# Rio Algom Mining LLC

**Re: License SUA-1473, Docket 40-8905  
Amendment Request – Pond 3 Erosion Protection Plan**

Reference: Amendments to Erosion Protection Drawing for Pond 3 area  
Task 3 Design Report  
Ambrosia Lake Mill, Grants, NM

**Design Memorandum for Placement of Filter Layers (Bedding Media) Below  
Riprap – Pond 3 Erosion Protection and  
Erosion Protection for the Area North of Pond 1  
Rio Algom Mining Company  
Ambrosia Lake Mill, New Mexico**

AMBROSIA LAKE MILL RIO ALGOM MINING, LLC. GRANTS, NEW MEXICO TASK 3 EROSION PROTECTION POND 1 TOE EROSION PROTECTION APRON		
PROJECT No. 1690030-300	DRAWING BY: RLH 2/28/02	SHEET 3 of 13
FILE NAME: 1690030S3-R2.DWG	MODIFIED BY: EJS 10/4/06 REVIEWED BY: COS

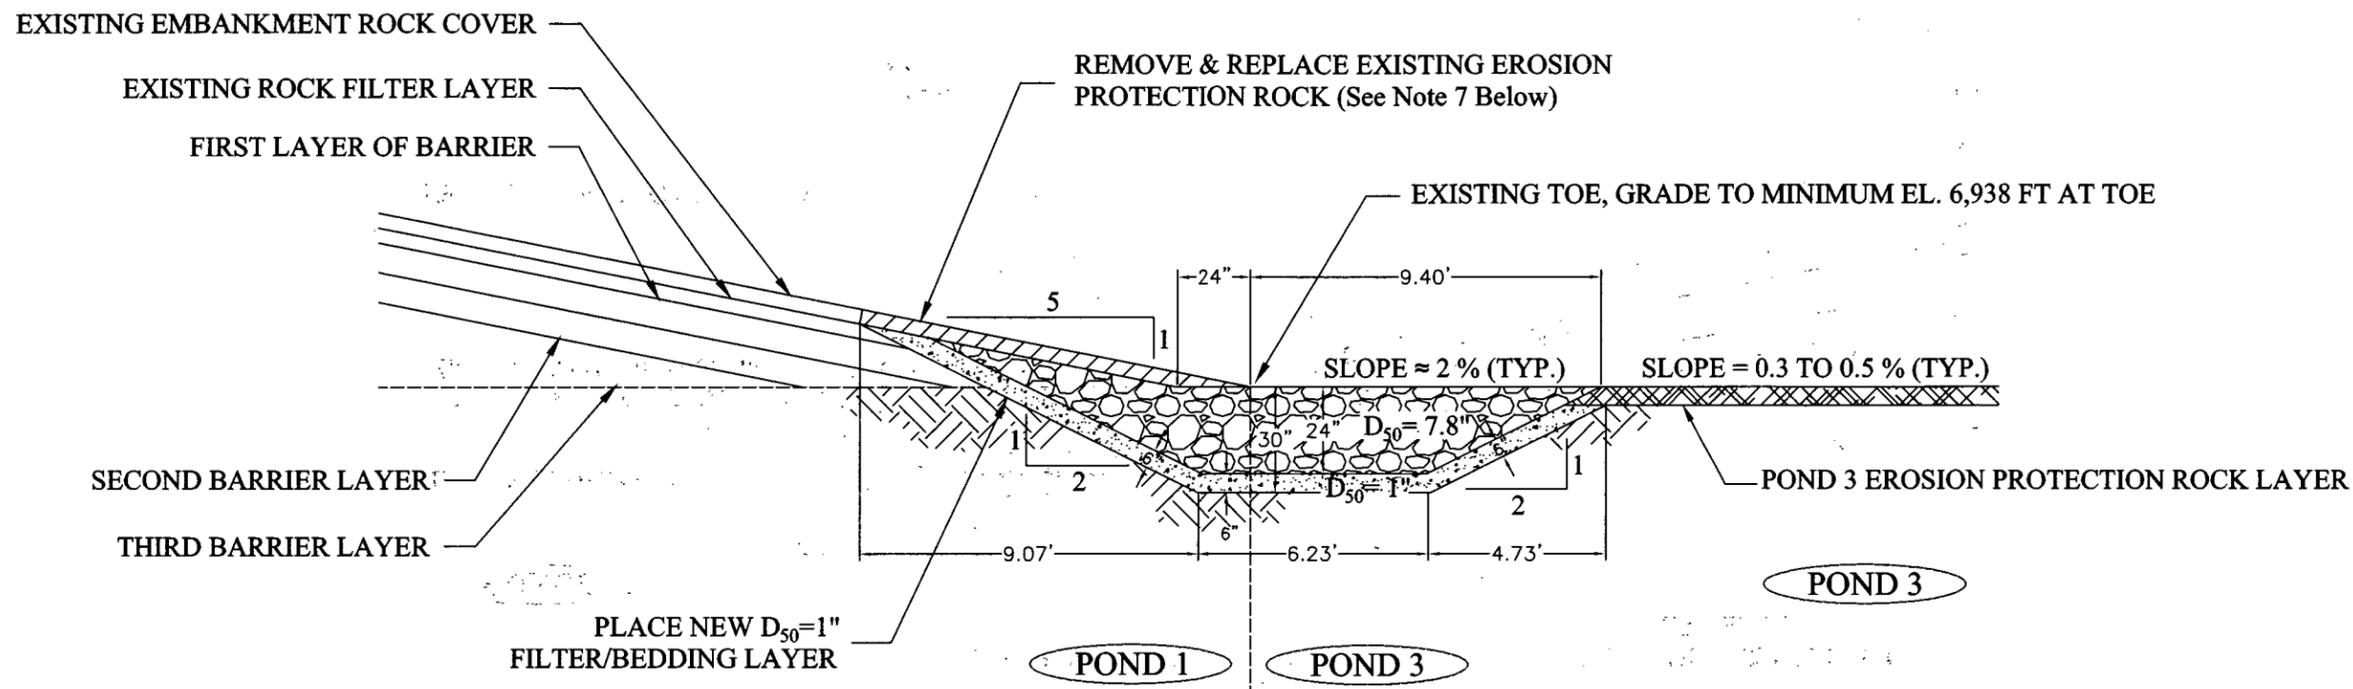
In addition to this request, Rio Algom identified a typographical error on one of the drawings associated with the previously approved plan. Review of Drawing 3 of 13 of the approved plan indicated an error in the rock size depicted on the print.

The rock sizing calculations contained in the submittal for the Pond 1 apron for run-off from Pond 1 east embankment slope onto Pond 3 top surface established a rock size for the apron of  $D_{50} = 7.8$  inches. The original print incorrectly assigned a  $D_{50} = 12$  inches. RAM has revised Drawing 3 of 13 to reflect the approved rock size of  $D_{50} = 7.8$  inches. The corrected Drawing 3 of 13 is included within the attached technical report.

- Rock sizing – we reviewed the rock size requirements at the Pond 1-Pond 3 interface. The correct rock size is  $D_{50}=7.8$  inches. Drawing 3 of 13 has been corrected to reflect this value.

- Rock Riprap for erosion protection aprons shall be placed in conformance with Appendix F of *Design of Erosion Protection for Long-Term Stabilization*, U.S. Nuclear Regulatory Commission's NUREG - 1623 Draft Report.
- Erosion protection aprons shall be sloped to the downstream edge with a minimum slope of two percent or at a slope that matches the slope of the natural ground, should it be steeper than two percent.
- Erosion protection apron excavations shall be constructed with 2H:1V slopes to permit placement of the filter materials as shown above. No tailings shall be excavated. The toe of tailings determines the alignment of erosion protection apron.
- The erosion protection apron shall be constructed of a rock diameter  $D_{50} = 7.8"$  conforming to the following gradation:

AMBROSIA LAKE MILL RIO ALGOM MINING, LLC. GRANTS, NEW MEXICO TASK 3 EROSION PROTECTION POND 3 TOE EROSION PROTECTION DETAILS		
PROJECT No. 1690030-300	DRAWING BY: RLH 2/25/02 MODIFIED BY: EJS 10/4/06 REVIEWED BY: COS	
FILE NAME: 1690030S4-R1.DWG		SHEET 4 of 13

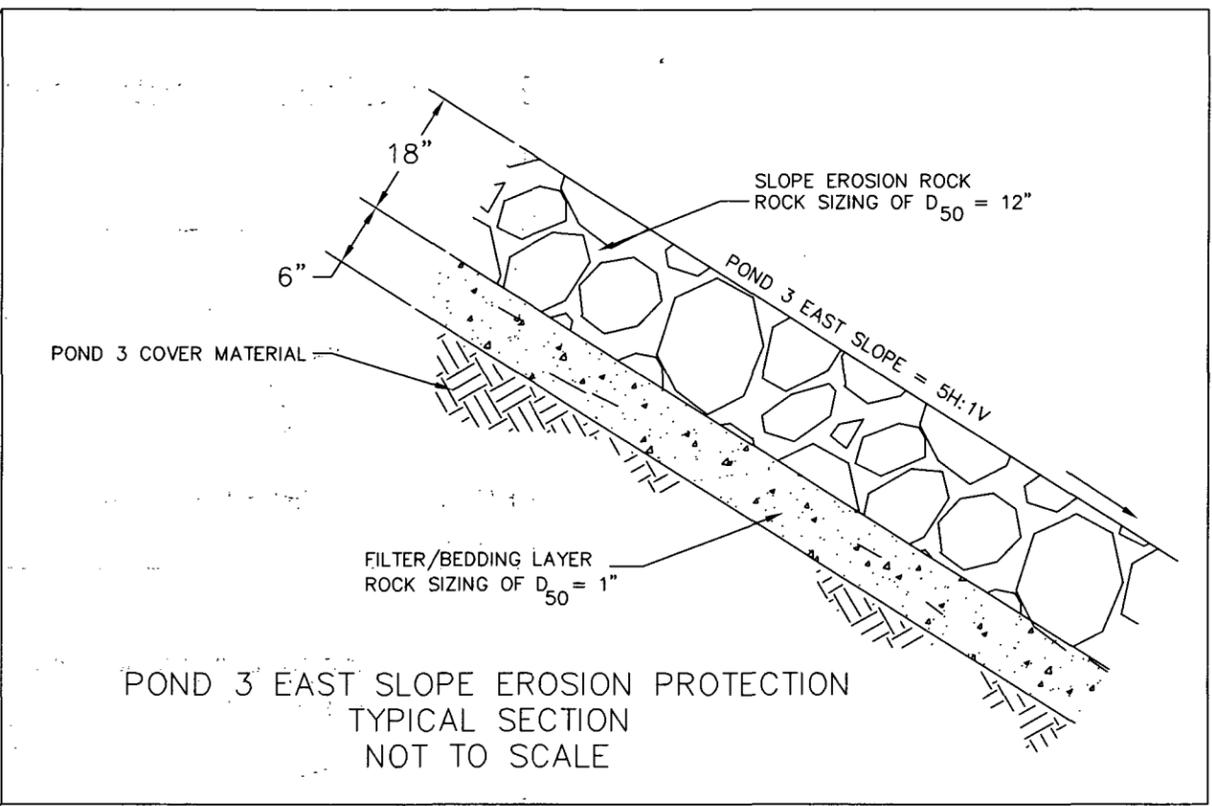
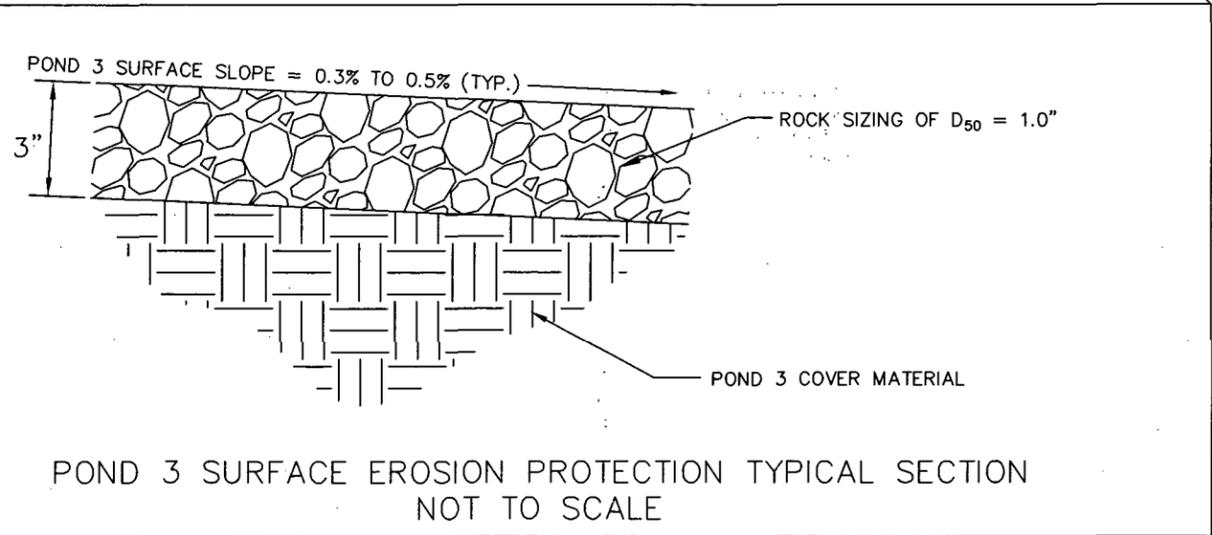
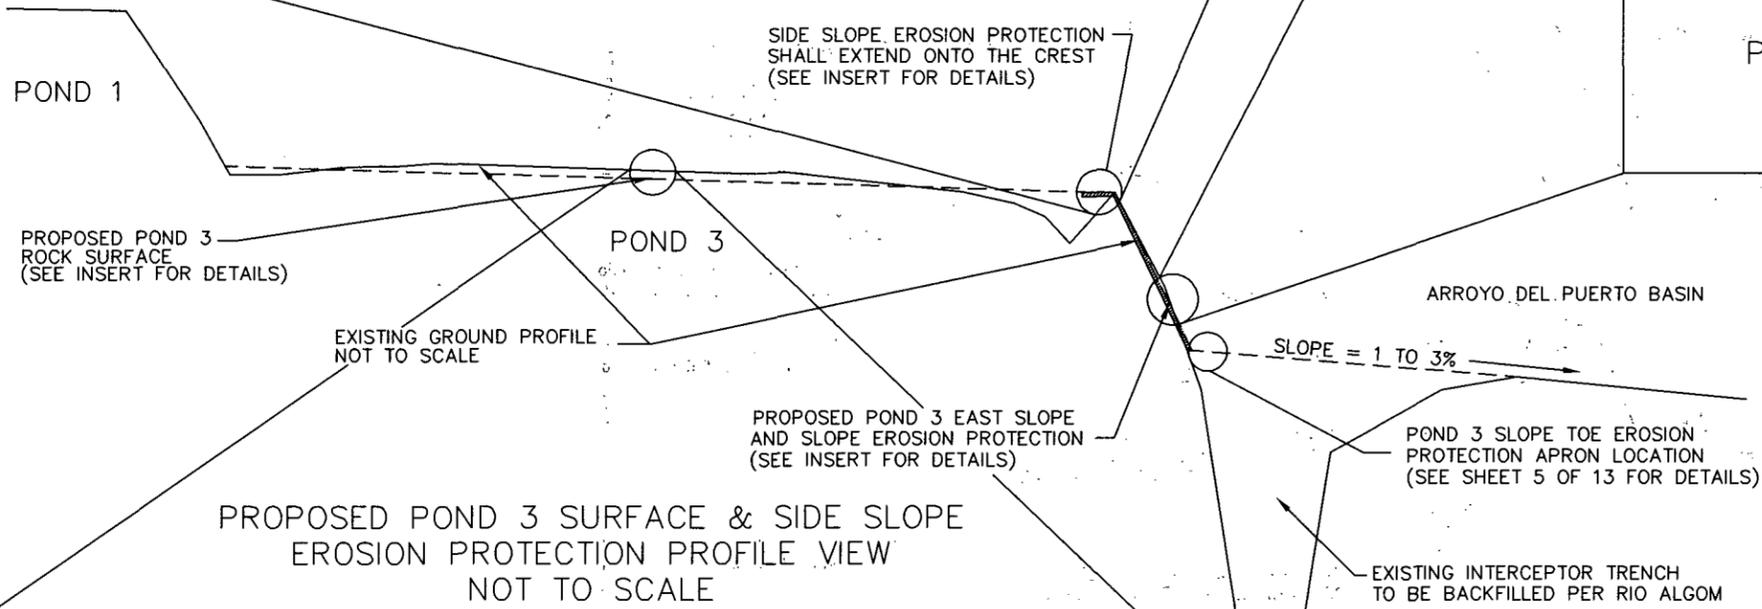
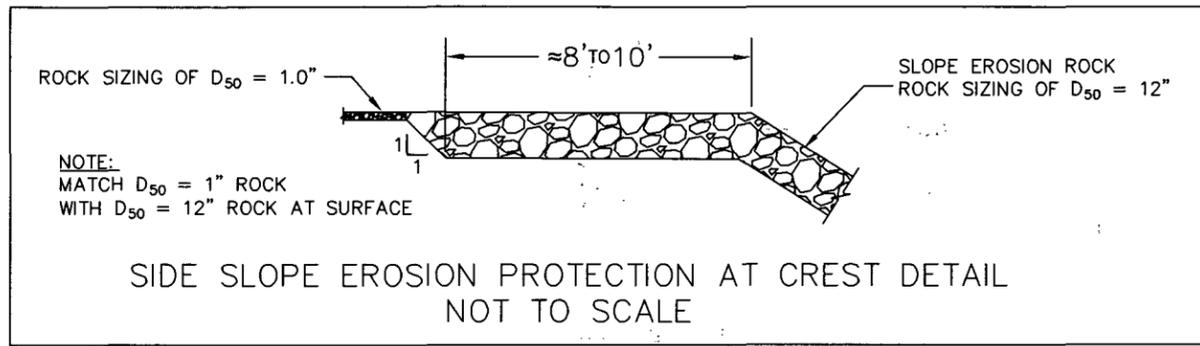
- An additional detail on Drawing 4 of 13 has been provided to illustrate the crest of Pond 3 and the blending of the side slope erosion protection ( $D_{50}=12''$ ) with the Pond 3 surface erosion protection ( $D_{50}=1.0''$ ).

AMBROSIA LAKE MILL RIO ALGOM MINING, LLC. GRANTS, NEW MEXICO TASK 3 EROSION PROTECTION POND 3 TOE EROSION PROTECTION APRON		
PROJECT No. 1690030-300	DRAWING BY: RLH 1/19/02	SHEET 5 of 13
FILE NAME: 1690030S5-R1.DWG	MODIFIED BY: EJS 10/4/06 REVIEWED BY: COS

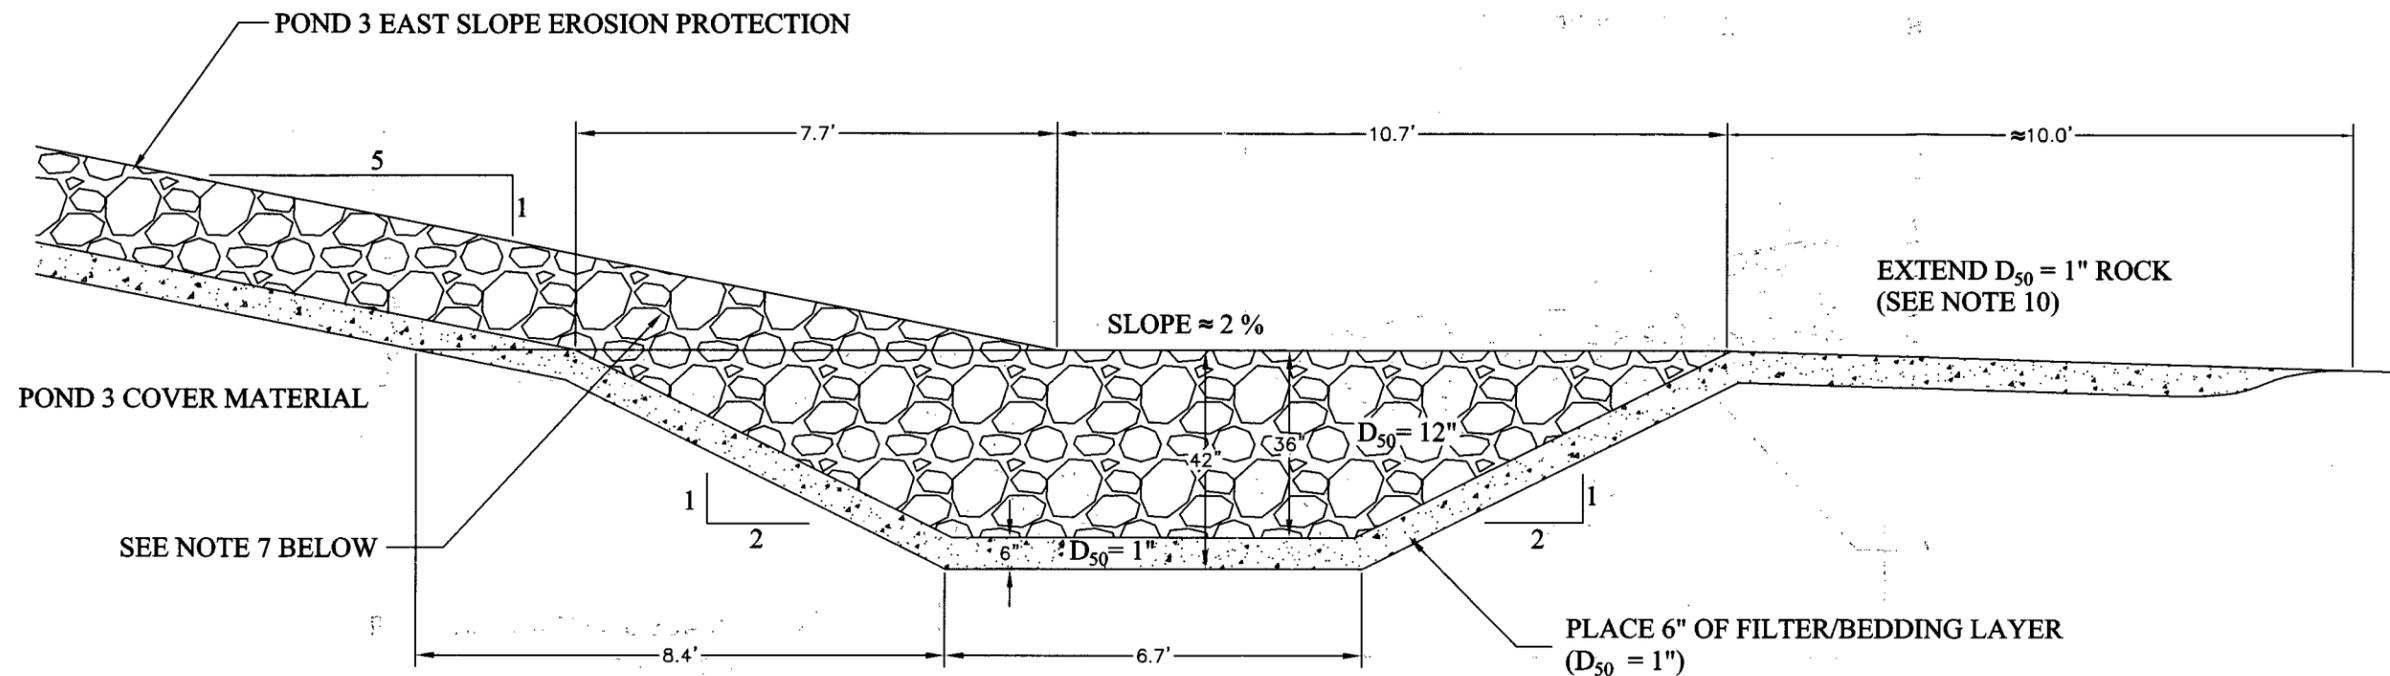
- Drawing 5 of 13 has been revised to extend the  $D_{50}=1.0''$  rock along the northeast and east sides of the Pond 3 embankment at the toe of the erosion protection apron. The extended rock shall be blended to match the natural grade surface within an approximate 10-foot distance.

10. Extend the  $D_{50}=1"$  rock along the Northeast and East sides of the Pond 3 embankment at the toe erosion protection apron. The extended rock shall be blended to match the natural grade surface within an approximate 10-foot distance.
